**Flat 02  
 Merlin House, Oak Hill  
 NW3 7LN**

**1523-NMA-XX-06-DR-A-00100**

**Upper Floor Plan**

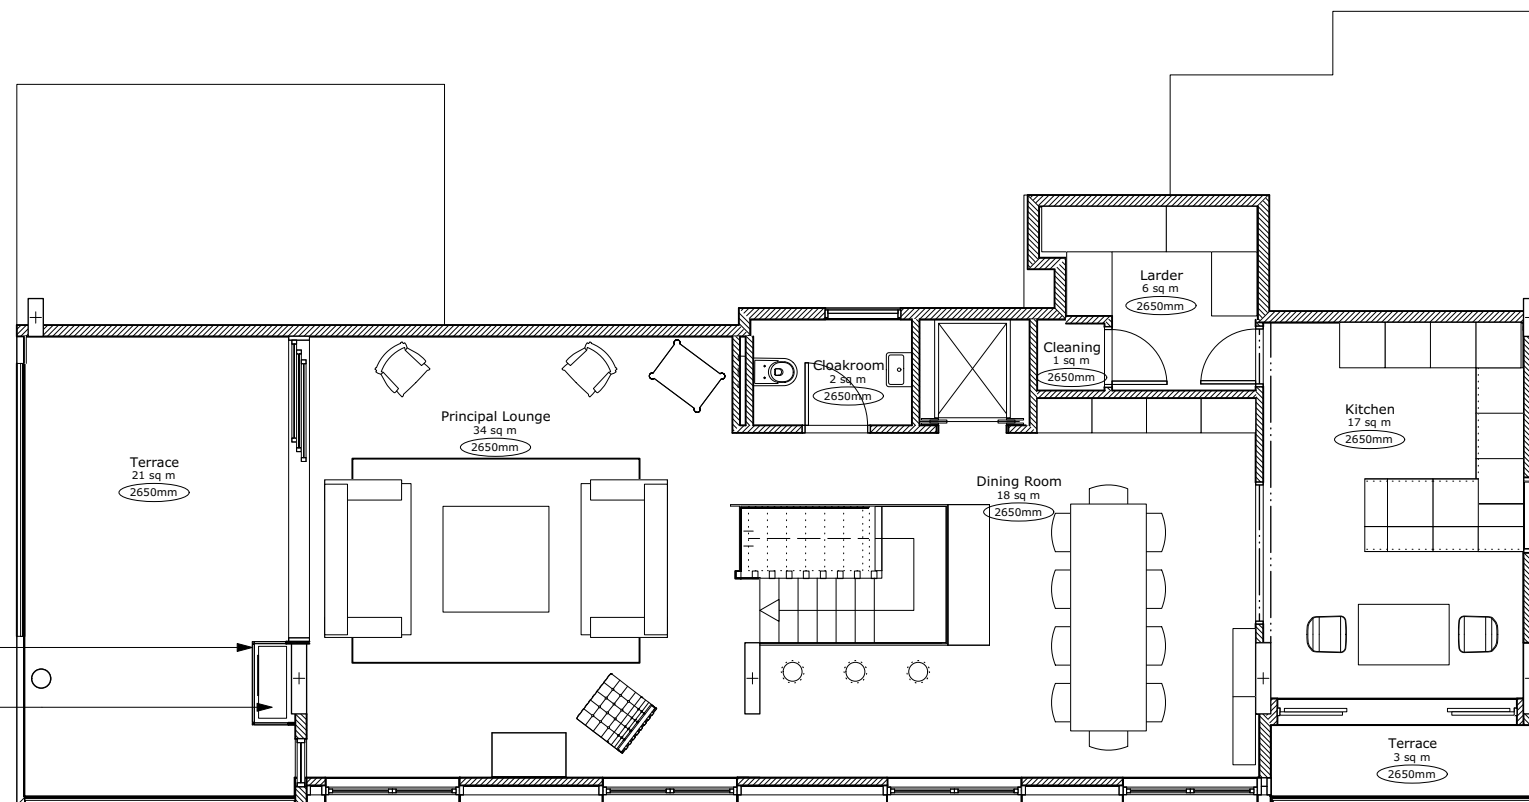
Powder-coated stainless steel louvred screening to air conditioning units behind  
 2 no. Air condensing units stacked behind  
 louvred screening

P5 6/11/17 Proposed air conditioning units and louvred screening  
 revisions:
